Office Action Summary	Application No. 10/661,793	Applicant(s) KAO ET AL.	
	Examiner Khiem D. Nguyen	Art Unit 2823

DETAILED ACTION

3. Claims 8-11 and 15-17 are rejected under 35 U.S.C. 102(e) as being anticipated by Mui et al. (U.S. Patent 6,924,088).

FIG. 2

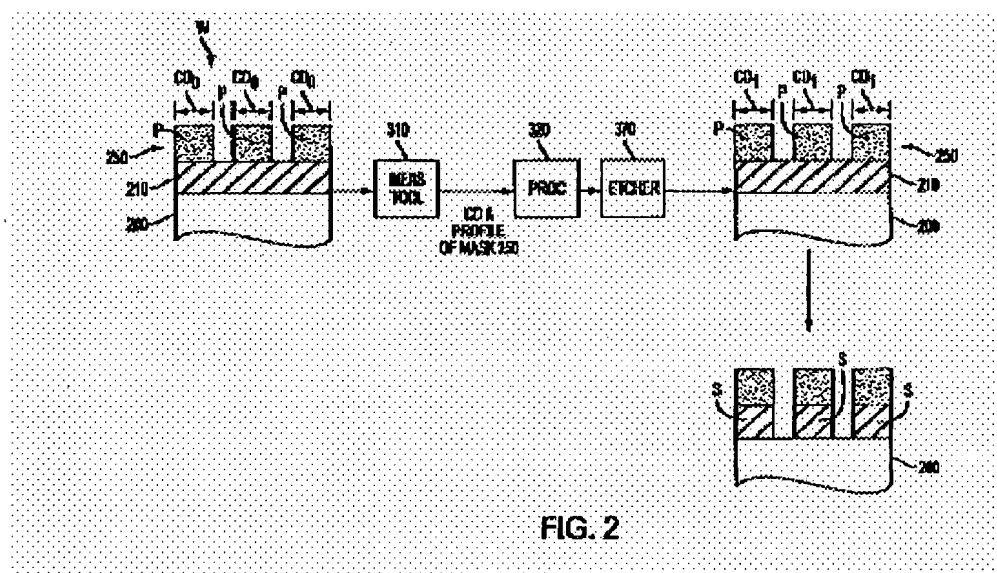
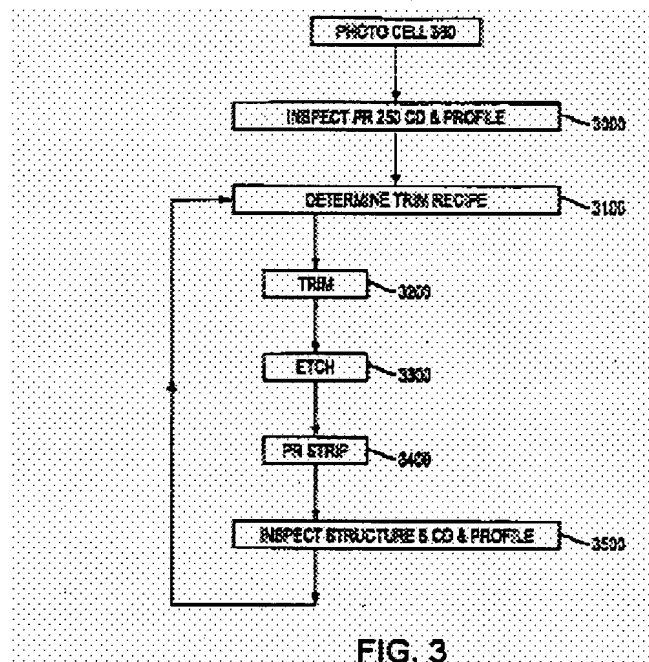
means **370** for creating an opening (via patterns **P**, col. 6, lines 29-30) through a layer of etch resist material **250** (col. 6, line 29) provided over the surface of a layer of insulating material (col. 6, lines 31-37) having been deposited over the surface of a substrate **200** (col. 6, lines 23-51 and FIG. 2);

means for measuring **310** an obtained critical dimension measurement of the opening created through the layer of etch resist material **250** (col. 6, lines 40-41 and FIG. 2);

means, including a feedback mechanism (col. 9, lines 11-24), for assuring that the obtained critical dimension measurement of the opening created through the layer of etch resist material **250** is within design specification, the feedback mechanism communicating with the means for creating an opening through a layer or etch resist material **250** to control the critical dimension (CD) measurement of the opening (col. 9, lines 11-44);

means 370 for creating an opening (via patterns P, col. 6, lines 29-30) through a layer of etch resist material 250 (col. 6, line 29) provided over the surface of a layer of insulating material (col. 6, lines 31-37) having been deposited over the surface of a substrate 200 (col. 6, lines 23-51 and FIG. 2);

FIG. 3

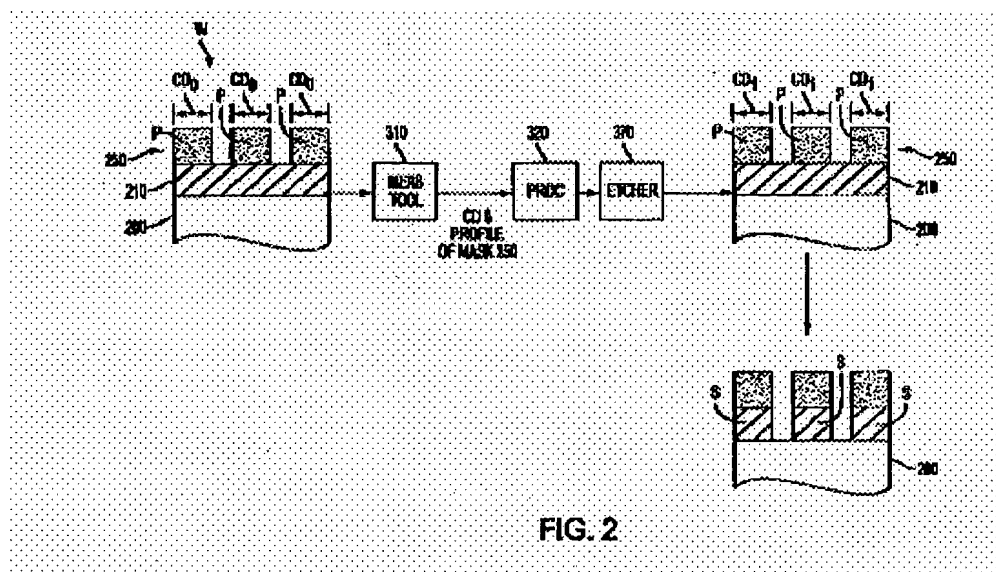
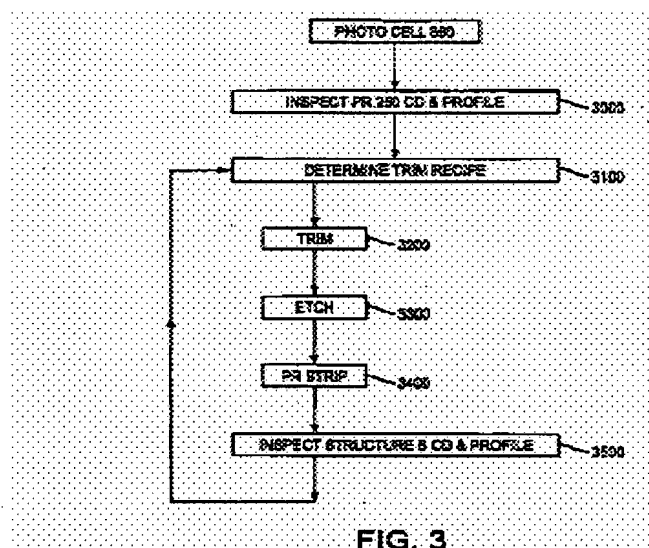
means, including a feedback mechanism, (col. 9, lines 5-24) for assuring that the opening created through the layer of insulation material is within design specification (col. 8, line 58 to col. 9, line 4 and FIG. 3).

means, including a feedback mechanism, (col. 9, lines 5-24) for assuring that the opening created through the layer of insulation material is within design specification (col. 8, line 58 to col. 9, line 4 and FIG. 3).
